PLANNING, ZONING, & BUILDING DEPARTMENT
PZ&B Staff Memorandum: Architectural Commission (ARCOM)

SUBJECT: ARC-24-0034 (ZON-24-0020) 336 AUSTRALIAN AVE W

MEETING: AUGUST 28, 2024

ARC-24-0034 (ZON-24-0020) 336 AUSTRALIAN AVE W (COMBO) - VARIANCES. The applicant, Sharon Handler Loeb, has filed an application requesting Architectural Commission review and approval for site wide landscape and hardscape modifications, installation of a generator and the relocation of pool equipment requiring variances. Town Council shall review the application as it pertains to zoning relief/approval.

PROPOSED SITE PLAN RENDERING

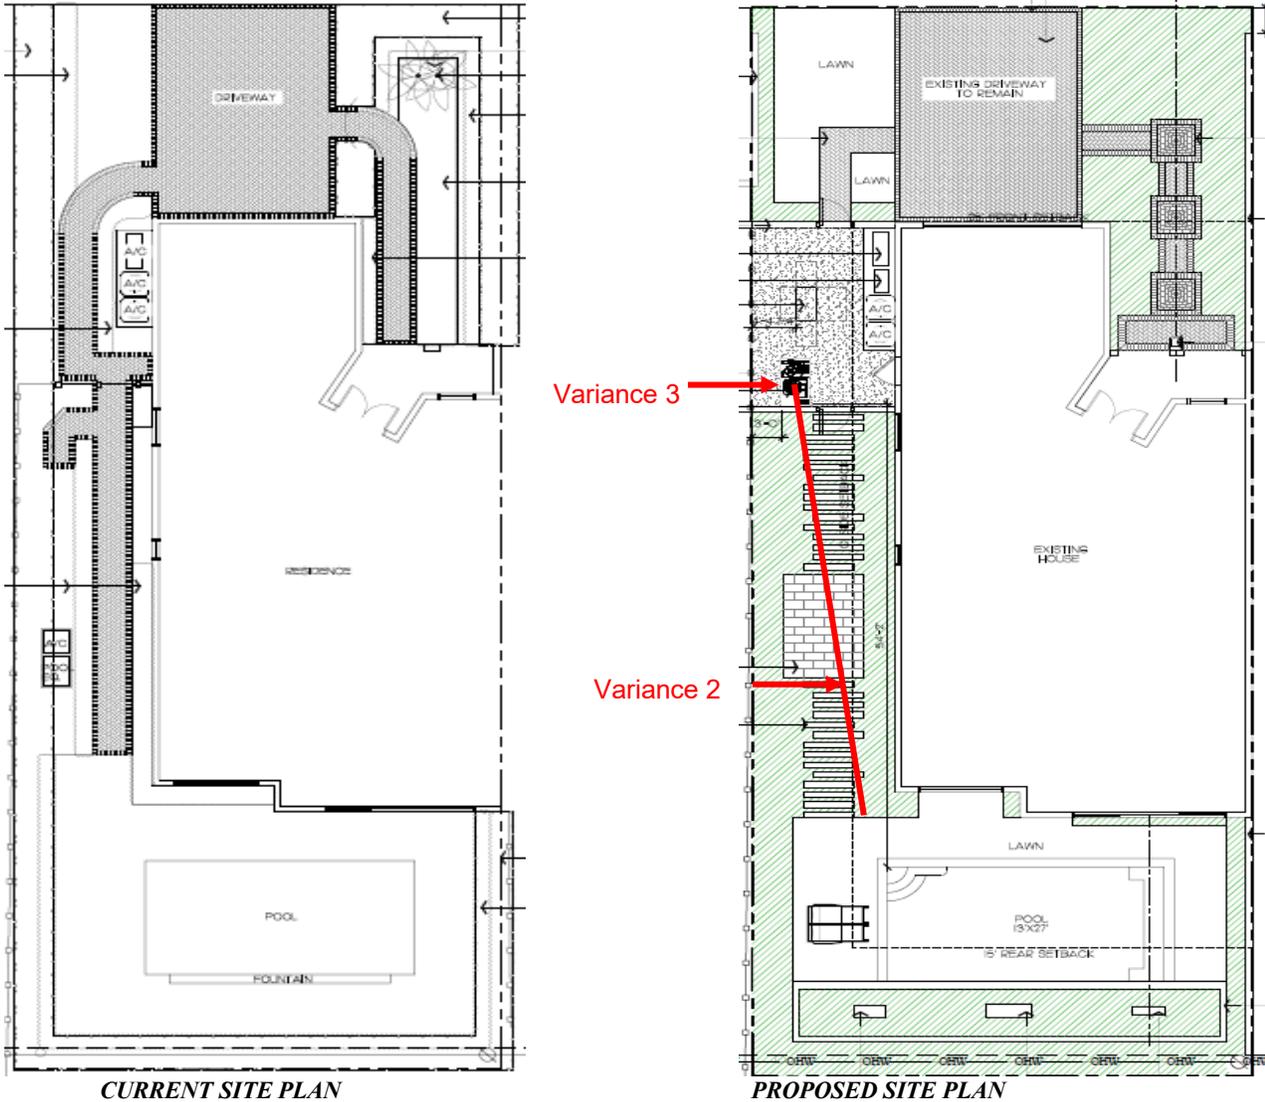
The applicant is proposing renovations to hardscape and landscape to half of an attached duplex parcel, including the relocation of mechanical and pool equipment, which will require variances related to setback and distance separations.

Code Section	Required	Proposed	Variance
<u>Variance 1:</u> Section 134-948	45% overall open space	36.35% LOS	8.65%
<u>Variance 2:</u> Section 134-1728(c)	Pool equipment @ 25'	54'-2"	29'-2"
<u>Variance 3:</u> Section 134-1728(c)	10' setback pool heater	3'	7'

Additionally, the applicant is proposing to modify more than 50% of the existing landscape open

space area. The zoning code requires that landscape open space calculations be brought up to current requirements if altering 50% of the existing landscape area. Although the applicant is proposing an improvement from existing conditions (36.35% proposed in lieu of the 26.74% existing), a variance is required for failure to meet the 45% minimum required. Although the applicant is proposing an improvement from existing conditions (36.35% proposed in lieu of the 26.74% existing), a variance is required for failure to meet the 45% minimum landscape open space required.

The proposed pool equipment location is within the required setback (variance #3) and spaced further than permitted from the edge of the water (variance #2).
